Mechanical change on the Rabbit-6 Pumphouse.

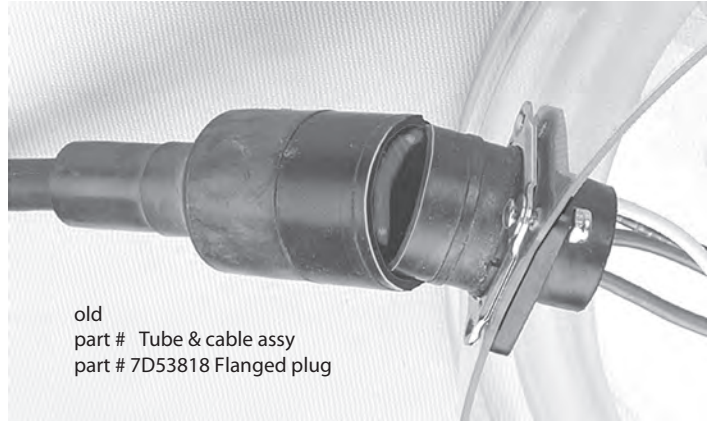
These two parts, the socket & boot has been replaced by

a cord that is directly and permanently wired into the pumphouse.

Order #2F01015 assembly which consist the following components for the conversion:

1. 6A05300 Screw
2. 6K01710 Washer
3. 6D01700 Nut, nylon ins.
4. 6D04600 Nut, plastic
5. 2F01081 "O" ring
6. foam gasket
7. 2F01013 Square plate to convert old type of socket & boot to direct hookup.
9. 2E90805 Strain reliever.
10. 7Y54508 Cable
